Office Action Summary	Application No. 10/520,092	Applicant(s) MARTIN, PETER JOSEF	
	Examiner GLORIA R. WEEKS	Art Unit 3721

DETAILED ACTION

3. Claims 19, 20, 22-26, 28-34 are rejected under 35 U.S.C. 102(b) as being anticipated by Niske (USPN 4,746,058).

Figure 1 of Niske

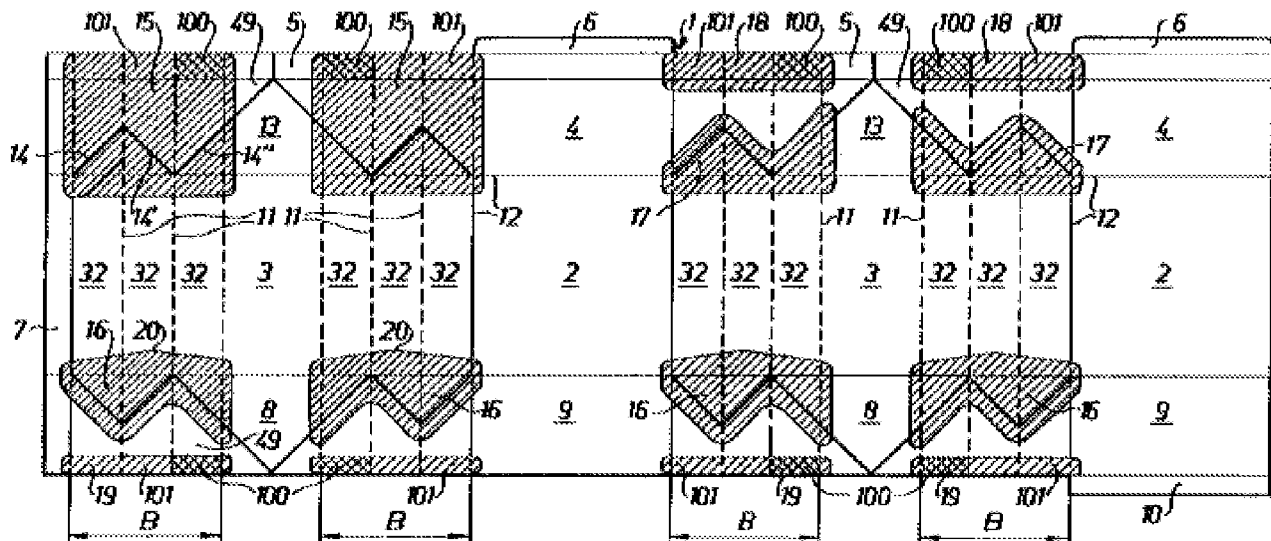
In reference to claim 19, 20, 22, 24-26, 28-30, Niske discloses a packaging material that is folded into a packaging and subsequently filled (column 1 lines 5-14 and 61-65), the packaging material comprising: longitudinal and transverse 12 fold lines; and stamped straight line markings 11, 14, 14', 14" separate from the fold lines, and having intersecting paths that correlate to dimensions of the packaging, the markings 11, 14, 14', 14" comprising a parallelogram (32 x1) within a first rectangular frame (32 x2) that has sides that are parallel to the longitudinal fold lines, and the first rectangular frame within a second rectangular frame (32 x3), such that a corner of the parallelogram (32 x1) bisects¹ a side of the second rectangular frame (32 x3); wherein the markings 11, 14, 14', 14" have a "U-shaped" cross-section. Page 5, lines 26-37 of Applicant's specification defines the phrase "U-shaped cross-section" as a configuration that projects into or out of a respective surface. Column 5 lines 21-27 of Niske disclose the markings 11, 14, 14', 14" as indentations, thereby meeting Applicant's limitation of

markings having a “U-shaped cross-section. As shown below, the stamped markings project² from an upper and lower side of the wall panel defined by the fold lines.
